RE: Netgear Incorporated, FCC ID: PY3-ANT24BX

Our responses to your comments on the above referenced application, are embedded with the issues that you raised.

Plot2 (Channel 11) □

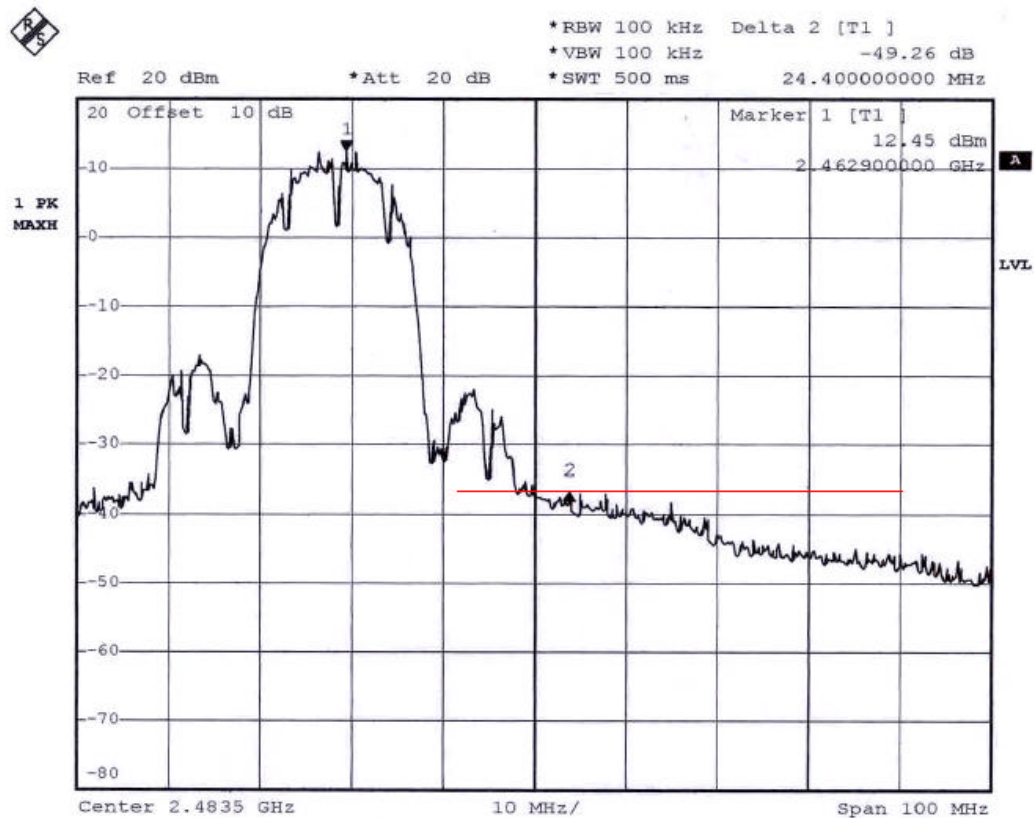
11) The band edge measurement above 2.4835 GHz appears that the marker 2 may not have been on the highest measurements above 2.4835 GHz band edge. Given how close the results were (0.2 dB from the limit), please verify that the marker was correctly positioned on the highest point above 2.4835 GHz.

The marker 2 is on the correct point on the graph. The tip of the marker's triangle and not the center/base of the triangle indicates the trace value. The tip is above all other out-of-band signals
